6 July, 2026

Addendum 2

**Columbus County Transportation
Whiteville, NC**

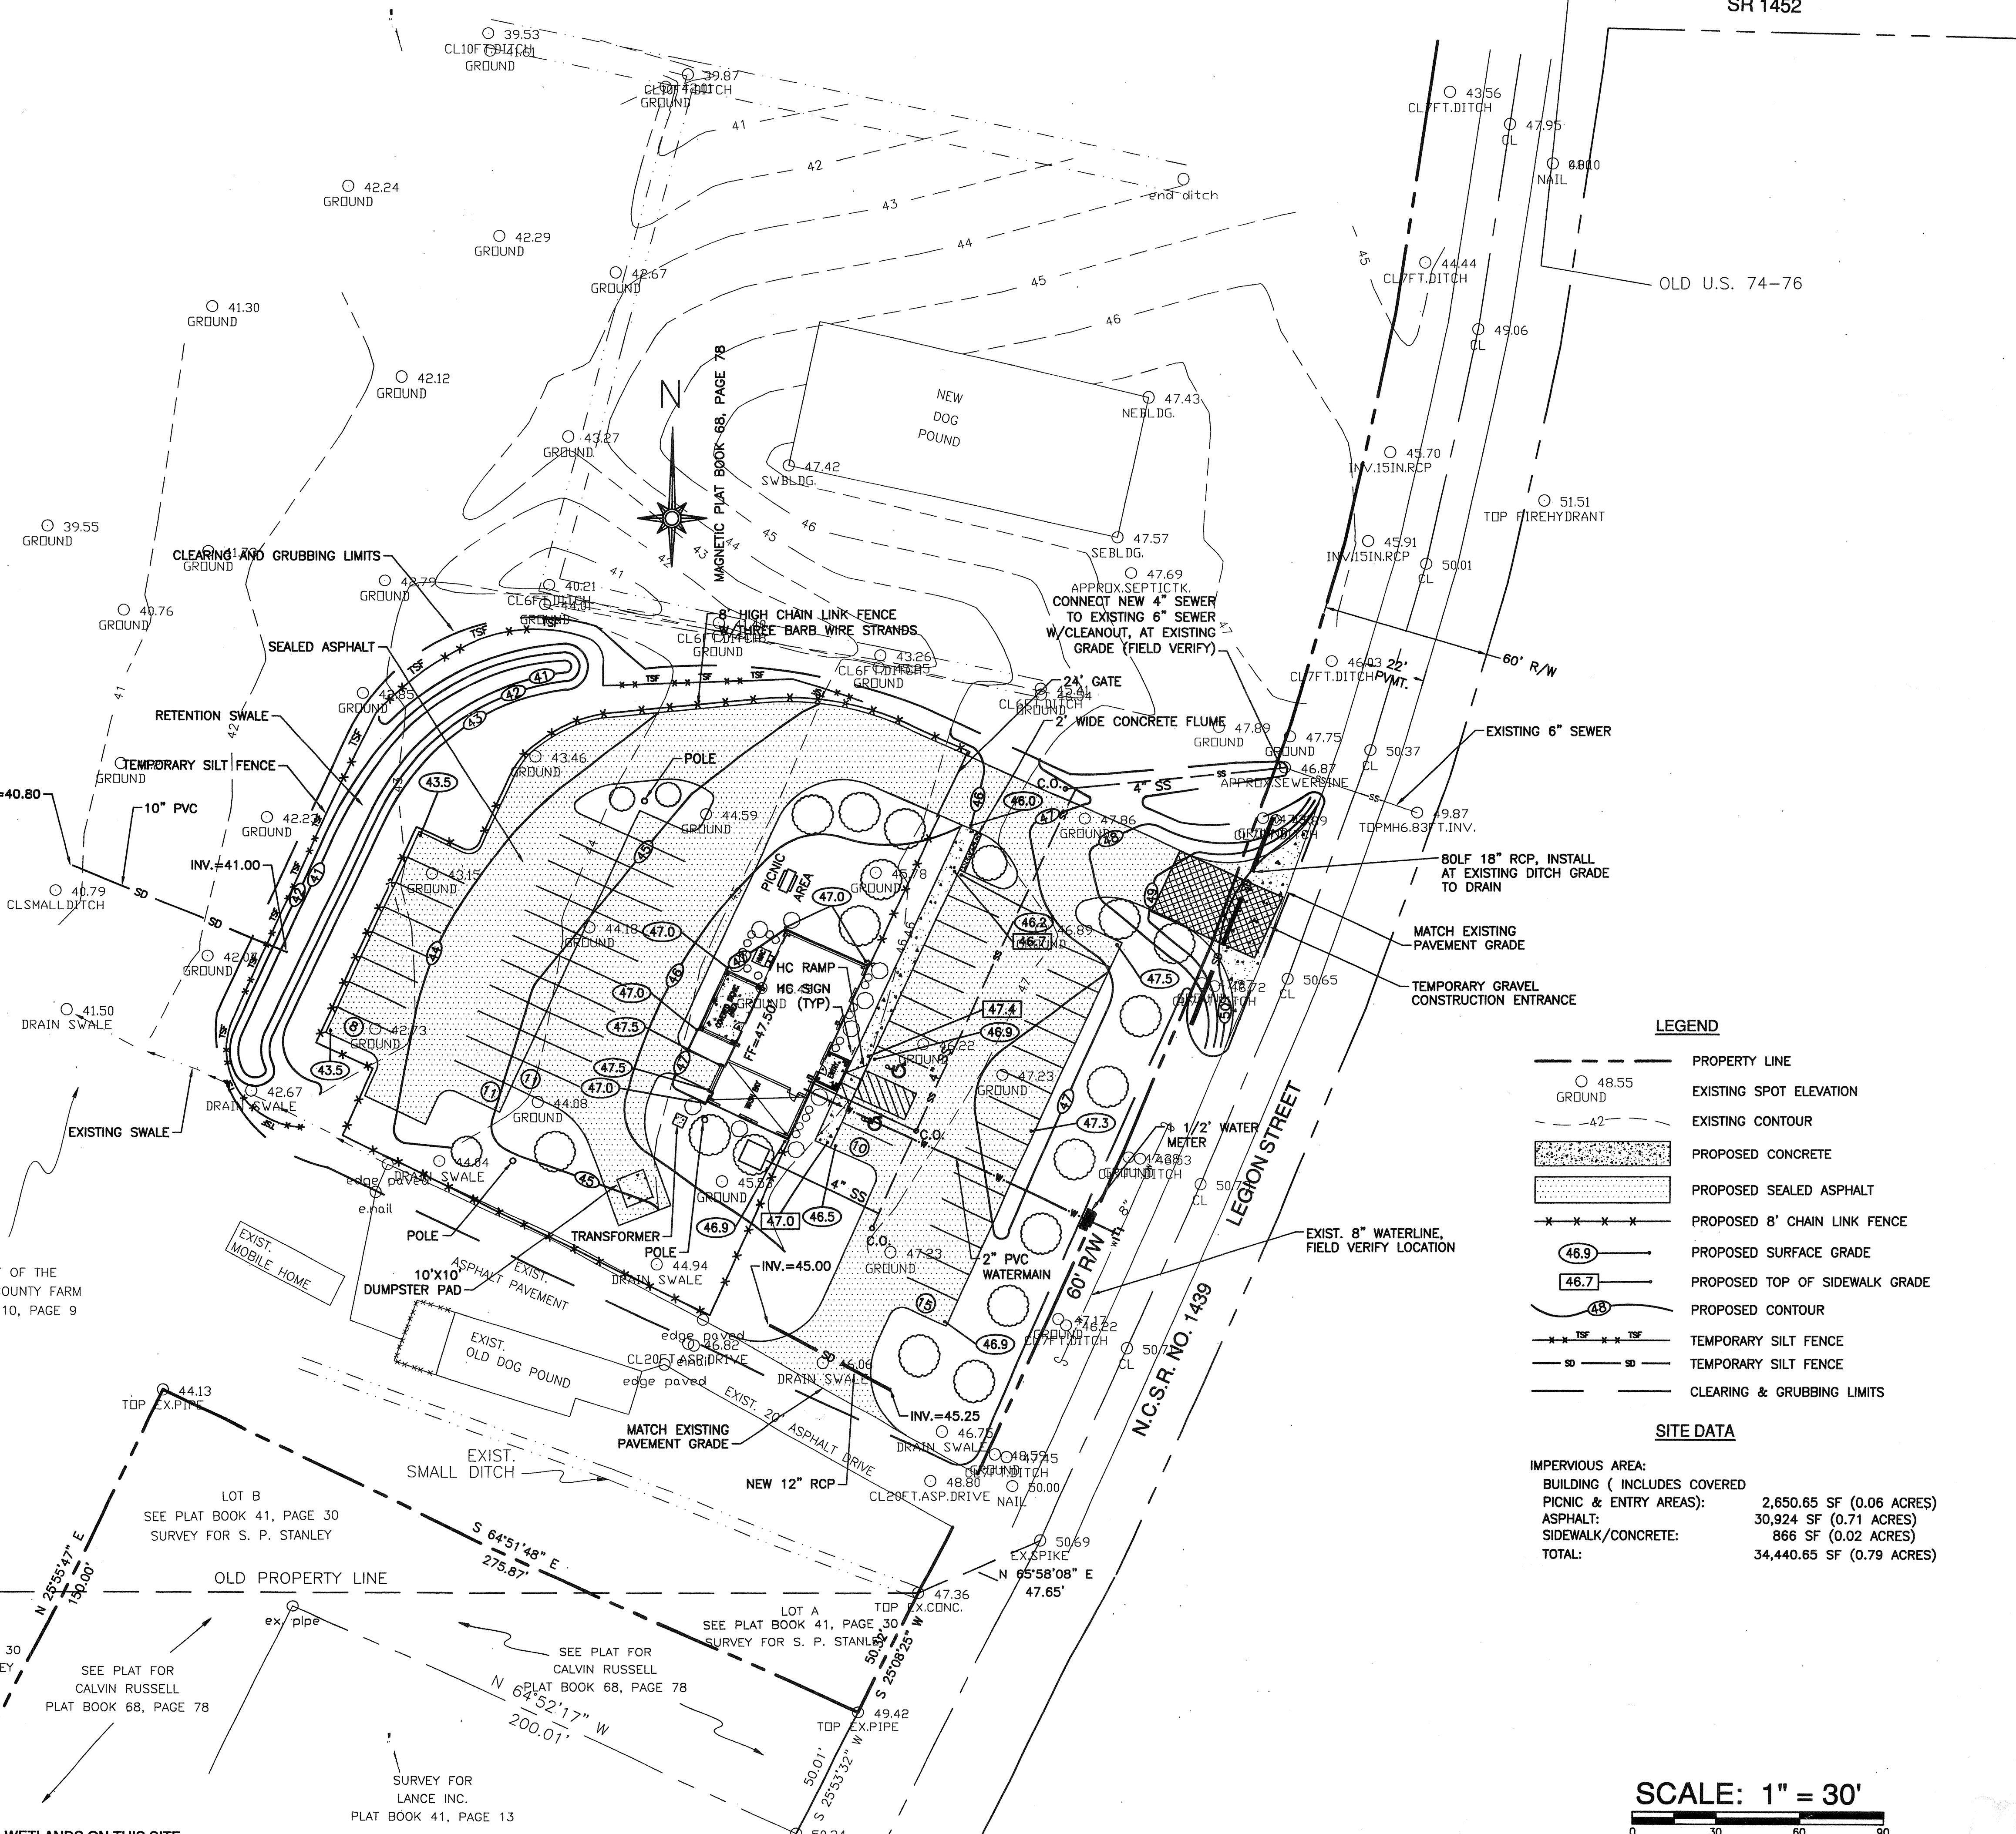
- For Contractor assistance see attached existing site plan for existing sewer line location.
Contractors to patch any asphalt disturbance to match existing at new sewer connections.
